# 1865 WOODMOOR DRIVE

## TOWN OF MONUMENT, COLORADO

### LANDSCAPE PLAN

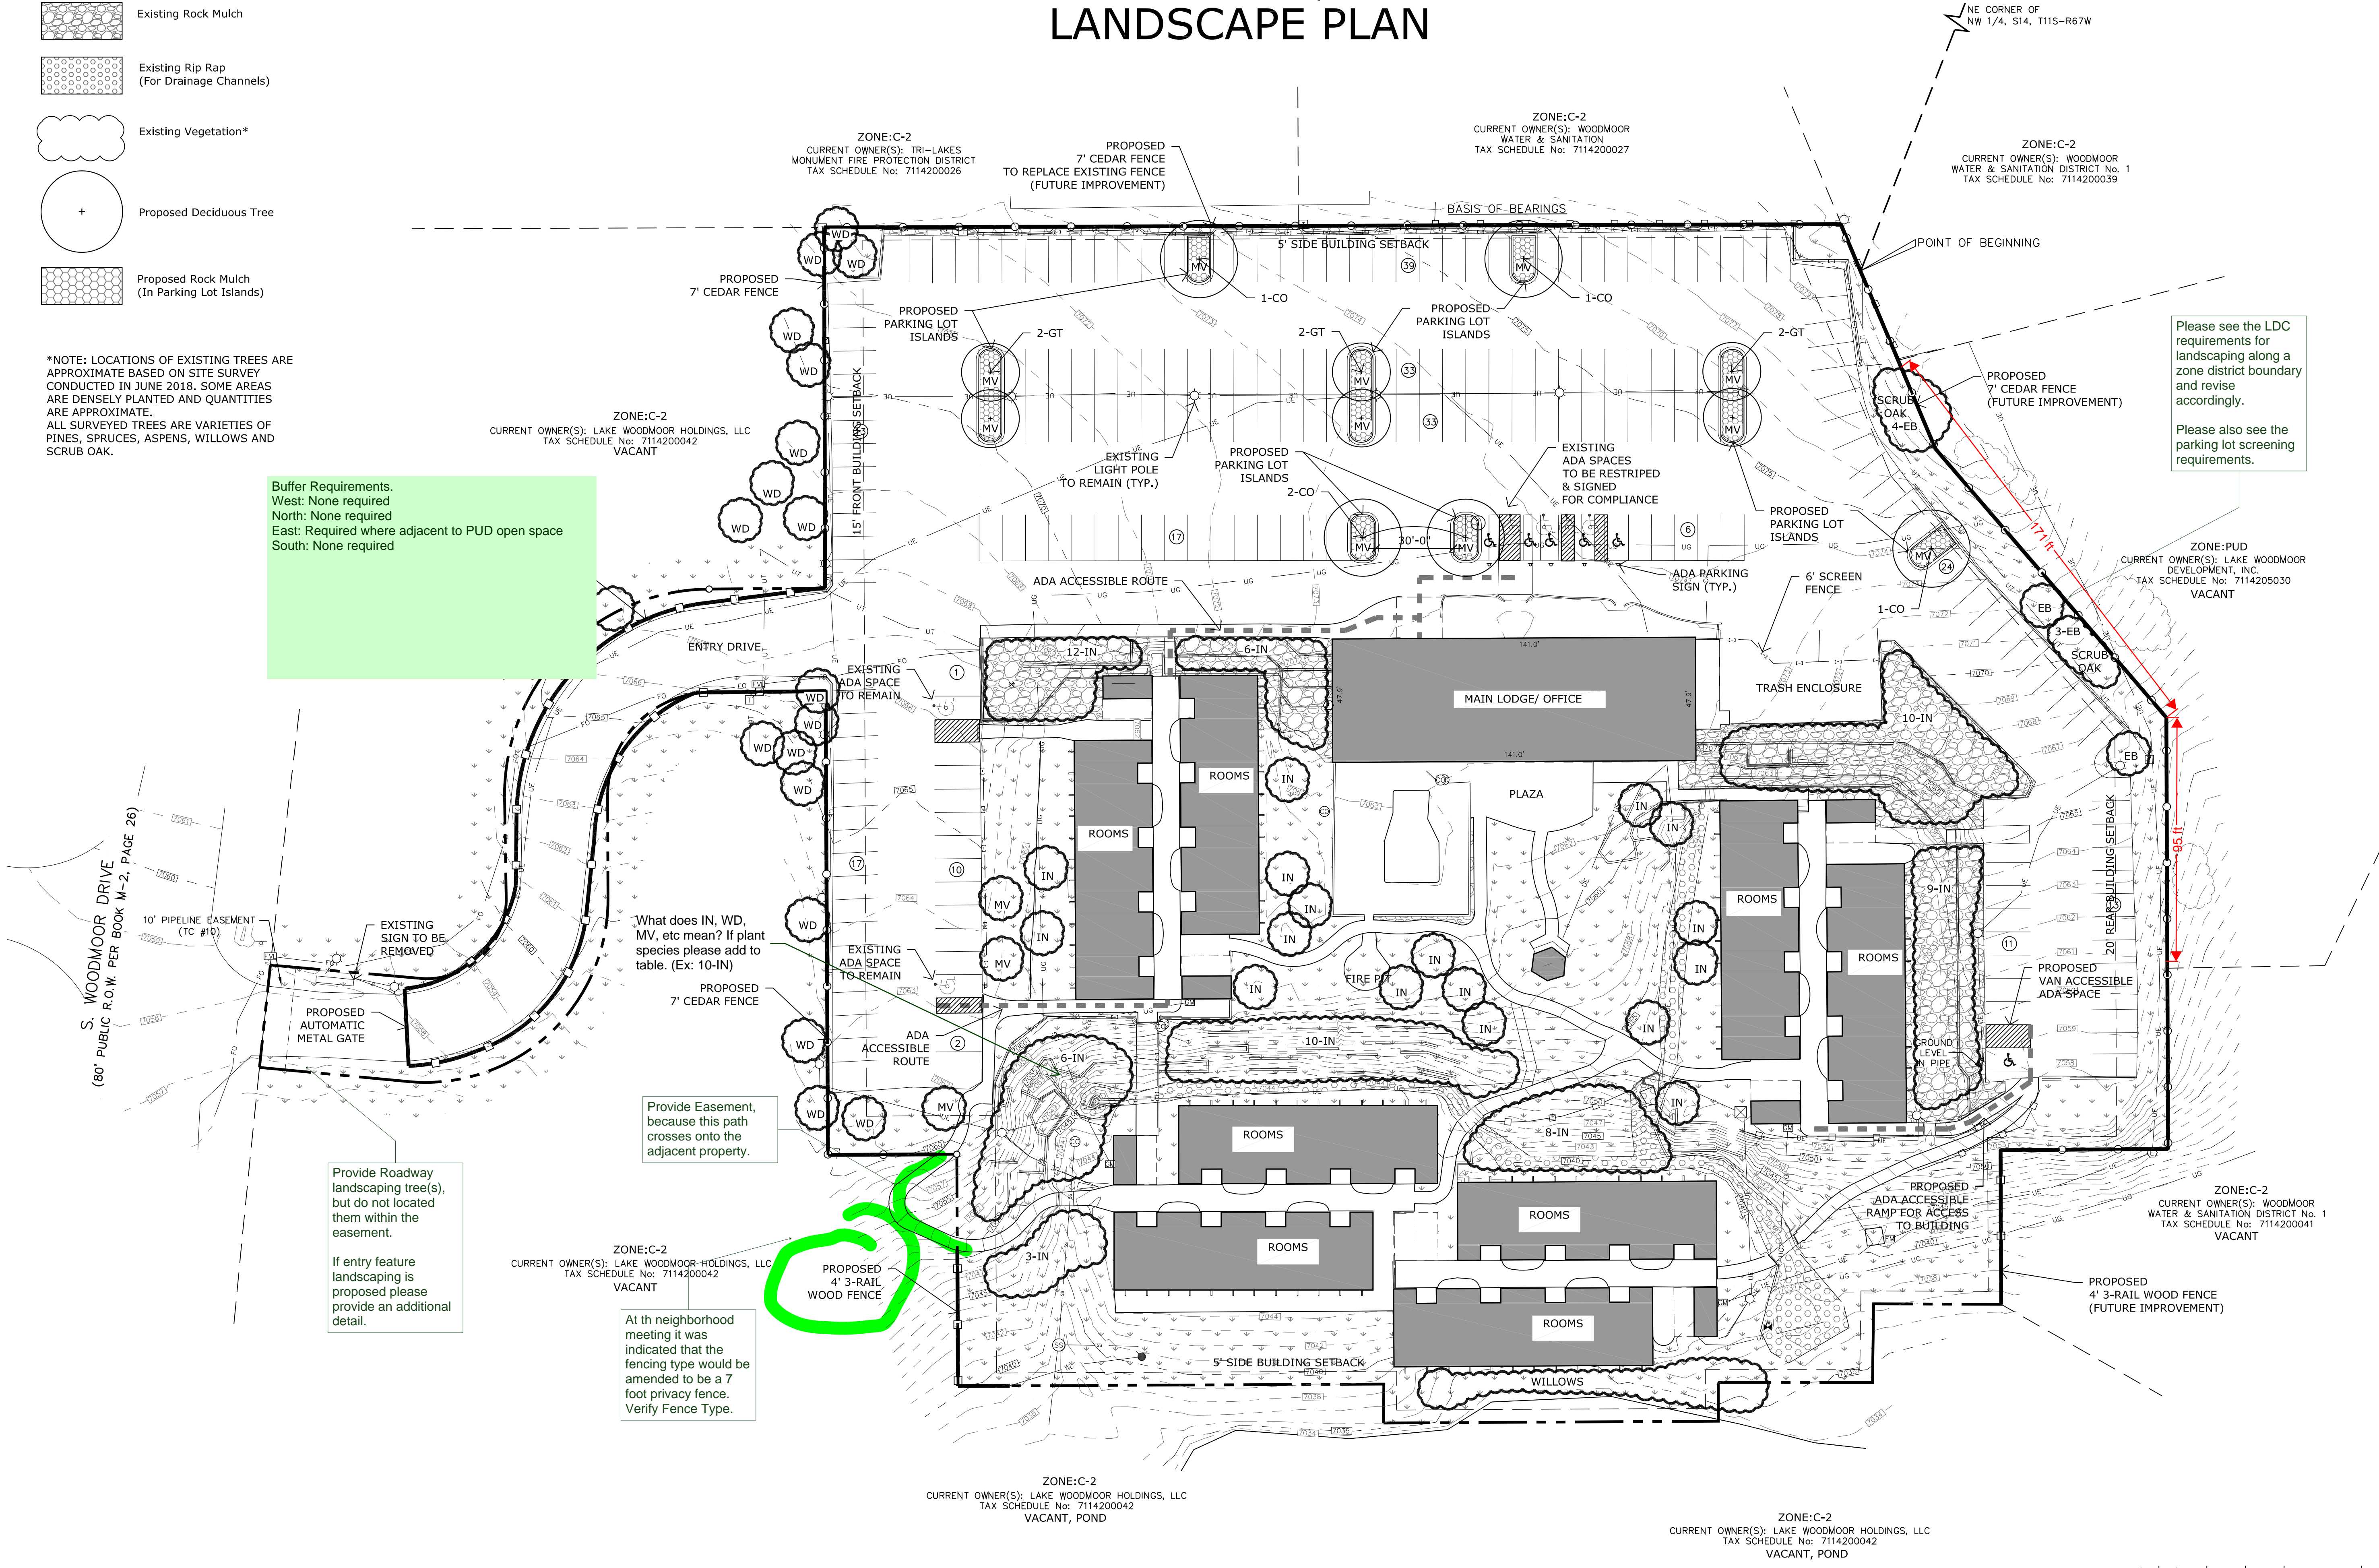
Please see the LDC requirements for landscaping along a zone district boundary and revise accordingly.  
Please also see the parking lot screening requirements.

What does IN, WD, MV, etc mean? If plant species please add to table. (Ex: 10-IN)

Provide Easement, because this path crosses onto the adjacent property.

Provide Roadway landscaping tree(s), but do not located them within the easement.  
If entry feature landscaping is proposed please provide an additional detail.

At th neighborhood meeting it was indicated that the fencing type would be amended to be a 7 foot privacy fence. Verify Fence Type.

#### LANDSCAPE PLAN NOTES & DETAILS

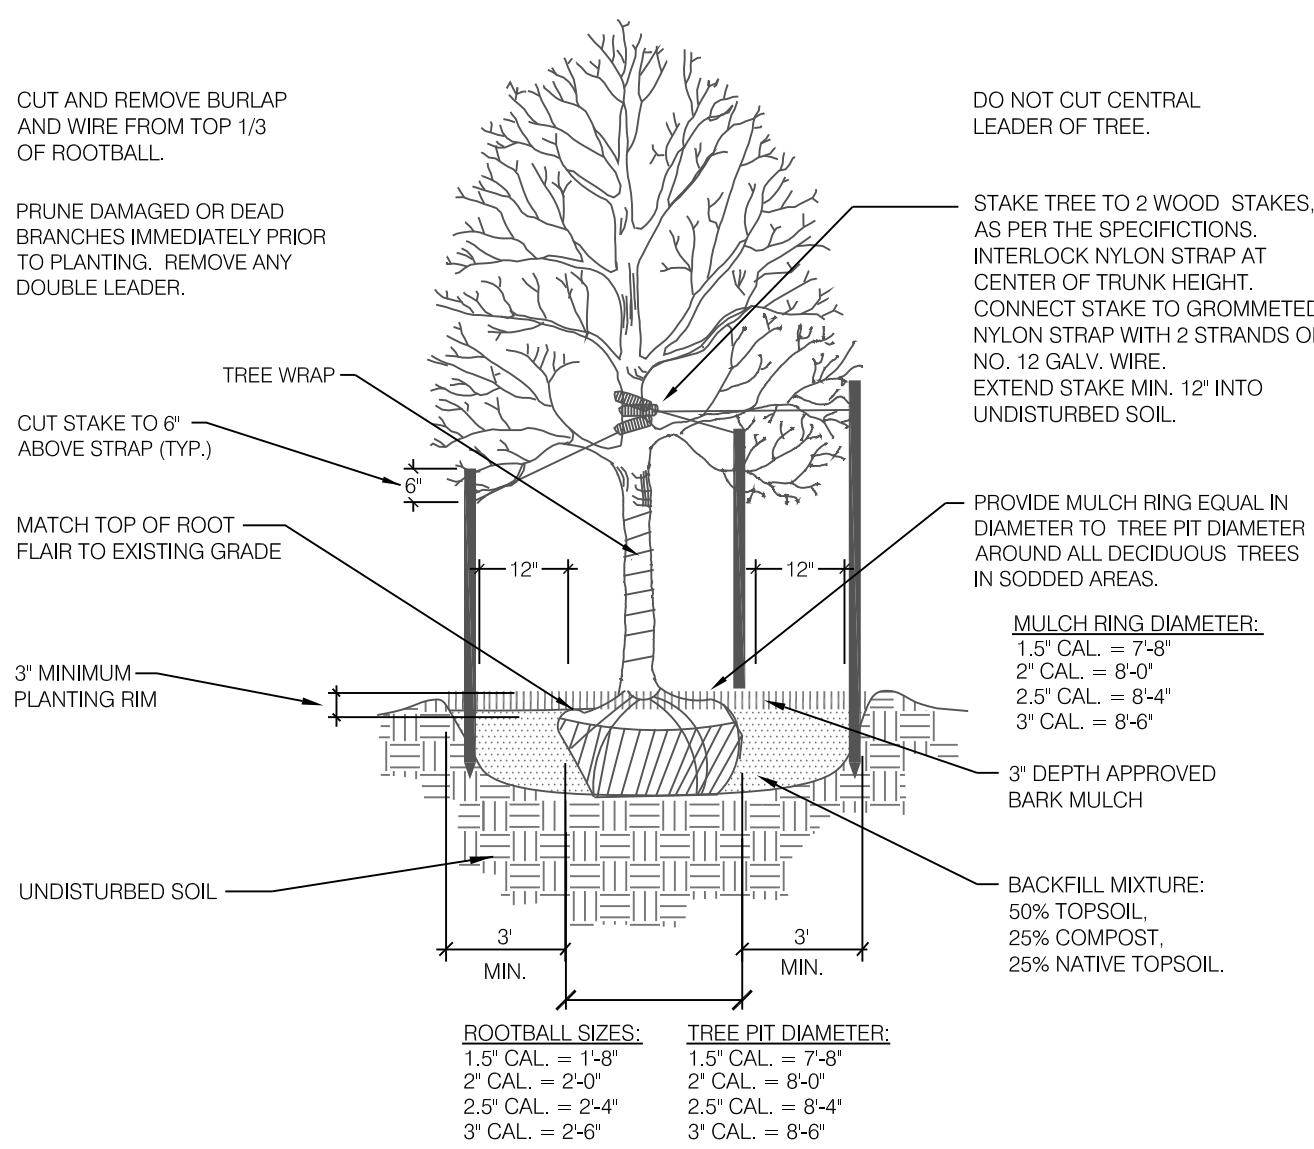
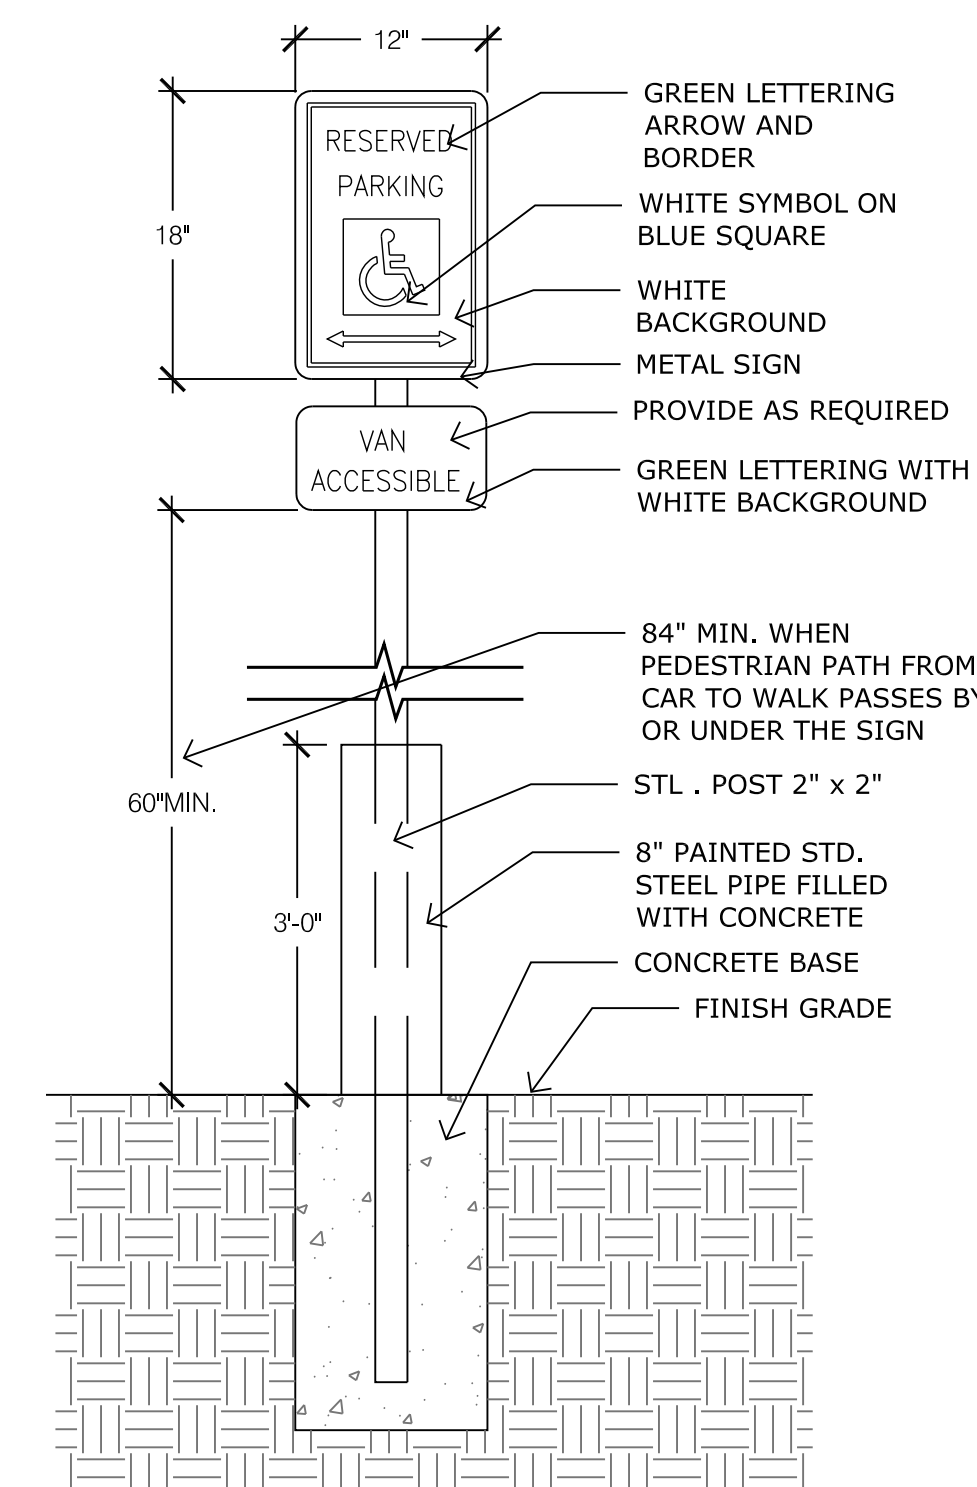
Provide fence detail(s)  
Provide trash enclosure detail.
